Project  
**PROPOSED 2 STOREY EXTENSION  
AT 1 REDLANDS COTTAGES  
REDLANDS LANE,  
EMSWORTH, PO10 7SN**

Title  
**PROPOSED FLOOR PLANS  
& ELEVATIONS**

| Date       | Drawn          | Scale      | Checked |
|------------|----------------|------------|---------|
| PL 88.16   | 49             | C          |         |

South (front) elevation

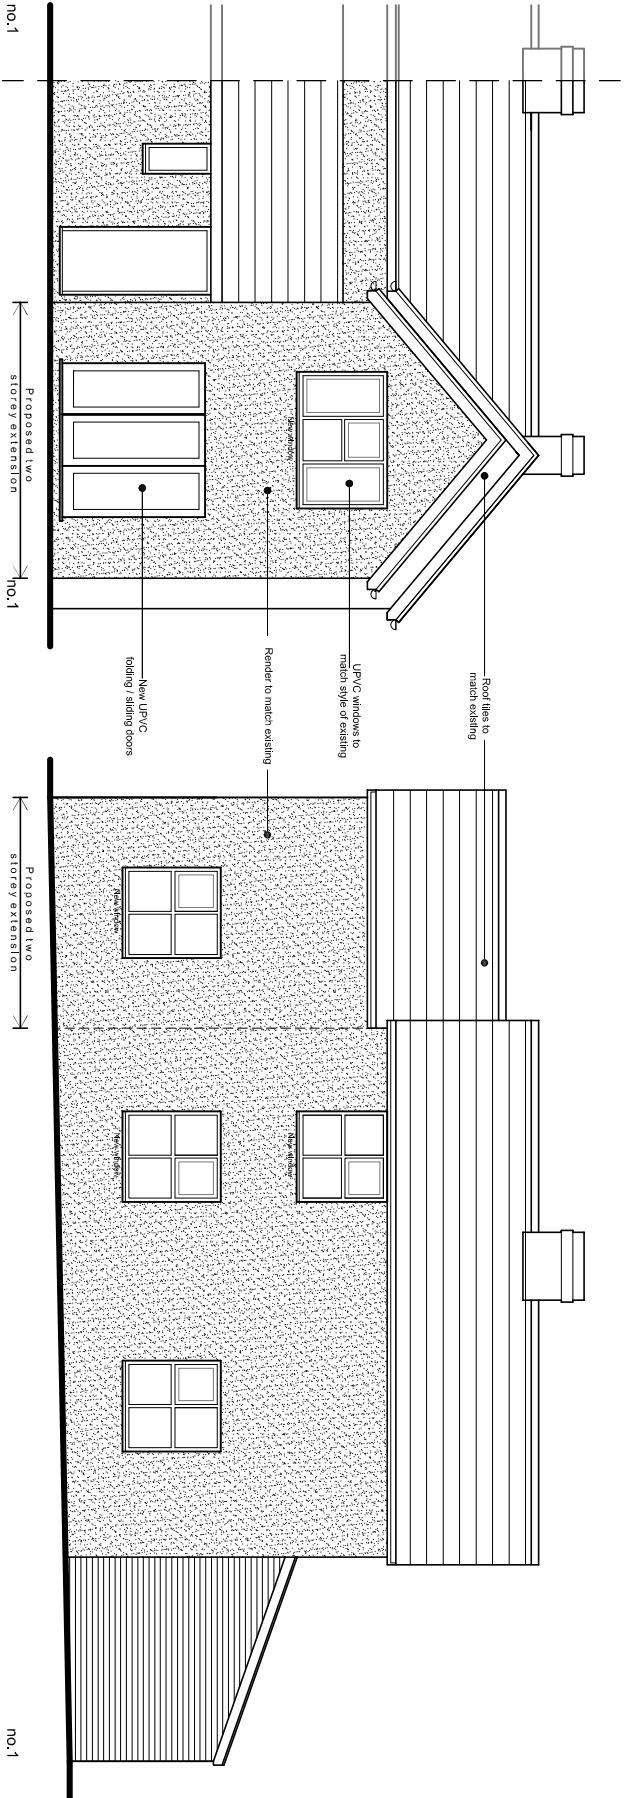
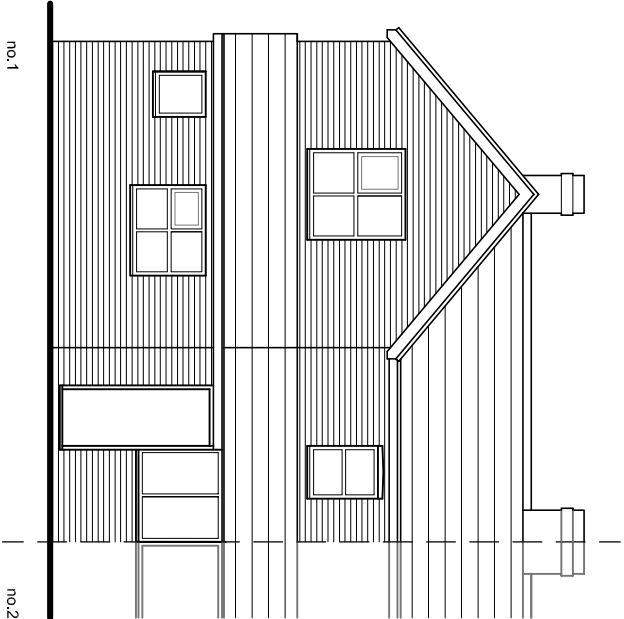
| REV | DATE     | NOTE                                                                   |
|-----|----------|------------------------------------------------------------------------|
| A   | 15.09.18 | High level windows changed to match style and size of existing windows |

East (side) elevation

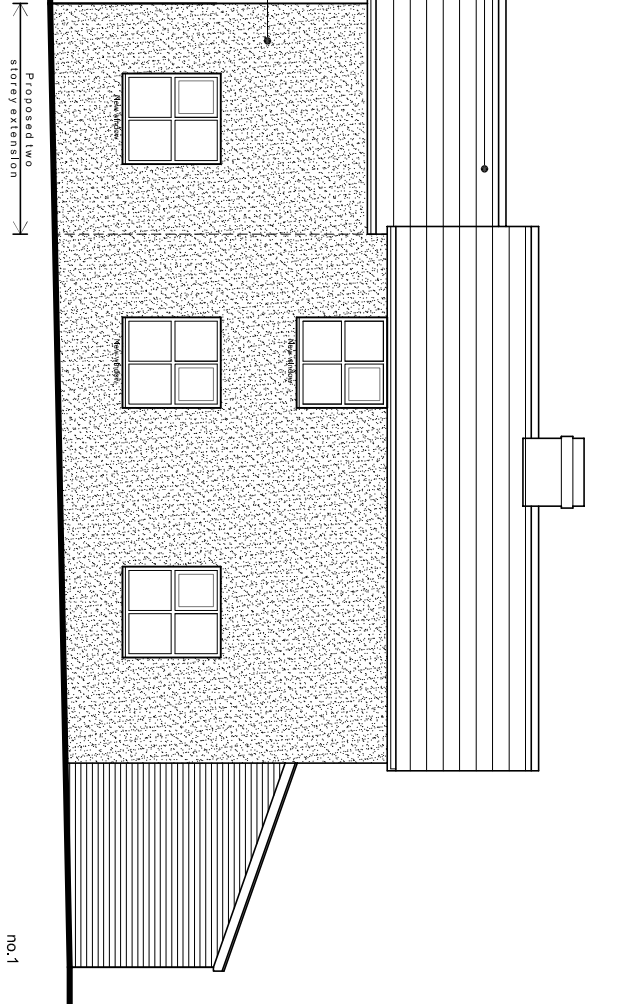
| REV | DATE     | NOTE                                                                   |
|-----|----------|------------------------------------------------------------------------|
| B   | 10.10.18 | East elevation, support in diagram, changed to support in elevation    |
